Flight Procedures Cover Page	Task Action: FLIGHT CHECK	Task Type: IAP	Estimated Chart Date: 03/19/2026	APWS Task ID: 18BF2A5E71DA4C0A869ECD398BD7D6E1	APWS Project ID: 00C896C3A8AF44F6BC889E6278105E1A
Procedure: ILS OR LOC RWY 17R AMDT 4		Enroute: NO	Specialist: Hirst, Charles		Agreement Number:
Airport ID: KDEN			Airport City: DENVER		State: CO
Facility ID: ACX	Facility Type: ILS	Flight Inspection Remark Type: New FC Slot

Procedure Comments:
REDESIGN MISSED APPROACH. REMOVE ALL REFERENCES TO DEN VOR IN PREPARATION FOR DEN VOR DECOM. AFS REQUIRED.

Denver, CO
Denver International, KDEN
ILS OR LOC RWY 17R

ILS or LOC RWY 17R DENVER INTL (DEN)

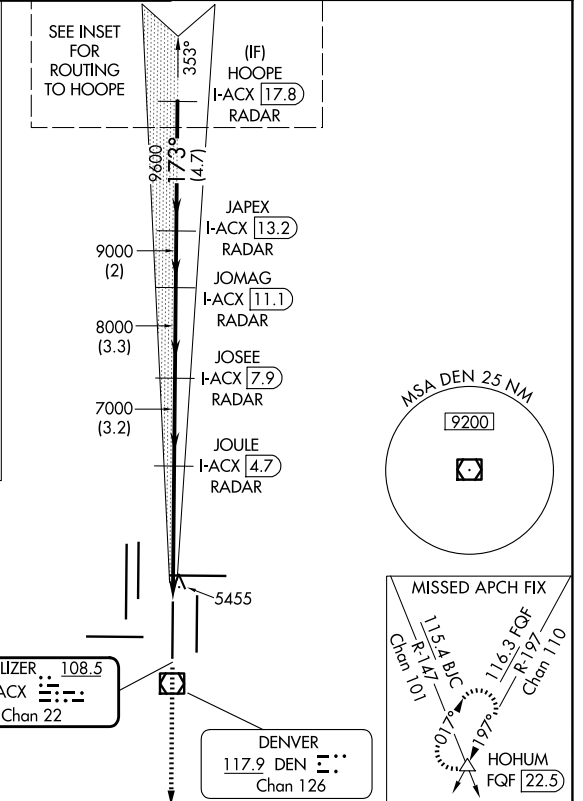
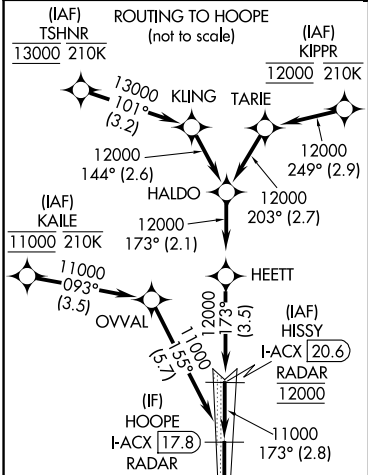
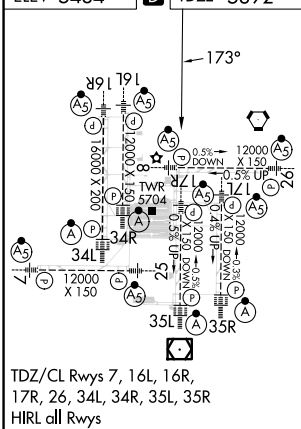
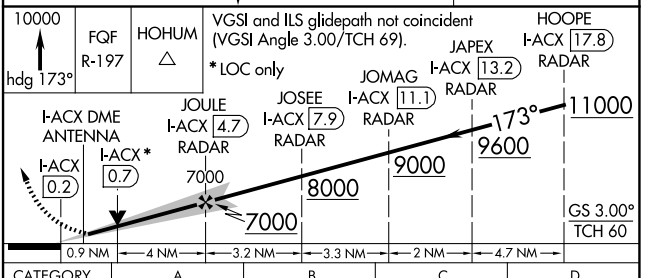
1. MISSED APPROACH CHANGED FROM "CLIMB TO 11000 ON HEADING 173 TO 4.15 DME BEFORE TURNING DIRECT FQF VORTAC AND ON FQF R-197 TO HOHUM INT/FQF 22.49 DME AND HOLD" TO "CLIMB TO 11000 ON HEADING 173 TO I-ACX 4.15 DME SOUTH OF I-ACX BEFORE TURNING DIRECT FQF VORTAC AND ON FQF R-197 TO HOHUM INT/FQF 22.49 DME AND HOLD"

MISSED APPROACH: Climb to 10000 on heading 173° and on FQF VORTAC R-197 to HOHUM INT/ FQF 22.5 DME and hold.
